Service Information Letter

SIL 4300-XXX-06

Electric Attitude Indicator

4300-XXX Series

Pitch indicator

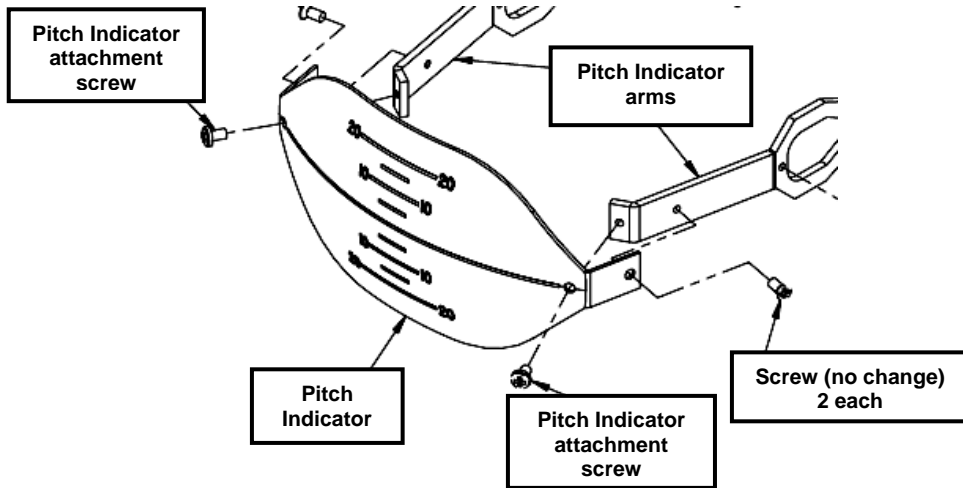
To notify persons performing maintenance of a product improvement to the pitch indicator attachment method. It has been determined by MCI Engineering during accelerated high vibration reliability testing that the possibility of a pressure crack could develop in the pitch indicator in the area of the screws used to secure the pitch indicator to the pitch indicator arms.

This information letter is an addendum to MCI 34-20-42, 4300-XXX Overhaul Manual. This SIL requires the inspection, during the next maintenance action, of the screws used to attach the pitch indicator to the pitch indicator arms. This change will be incorporated into future revisions of the Overhaul Manual.

While performing maintenance on any 4300-XXX Series Electric Attitude Indicator the two front attachment screws that secure the pitch indicator to the pitch indicator arms should be checked for head type. If the screws are flat head they should be replaced with the pan head screws listed in the materials section of this SIL.

In addition, check the area around the screws to insure that there has been no cracking of the pitch indicator. If cracking is observed it is suggested that the pitch indicator listed in the material section of the SIL also be replaced.

If the screws are pan head no further action is needed.

MCI P/N	DESCRIPTION	QUANTITY
90-003-00010	Screw, 0-80X3/32, Pan, Phil, Bk (replaces 8013385, 90-004-10010)	2
9015593	Pitch Indicator, Standard (shown)	1
9015741	Pitch Indicator, High Resolution
